Addendum Number One

To The Drawings and Specifications for
Hadley Middle School – Wichita, Kansas
Wichita Unified School District # 259

Issued: April 16, 2010

HANNEY & ASSOCIATES ARCHITECTS

3.9 Sheet A1.2

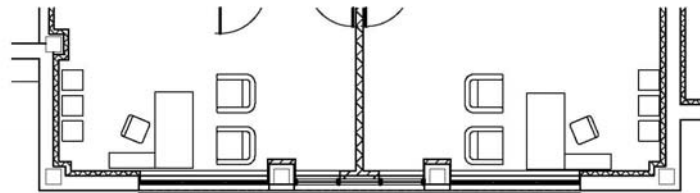
The existing exterior window between E124 and E125 is shown incorrectly. The existing window is divided in 3 equal lites similar to the adjacent windows. This project shall replace the center lites of glass with spandrel glass (glass type 7). The other windows existing vision glass shall remain. The wall between the two offices will meet this window in a fashion as illustrated below.
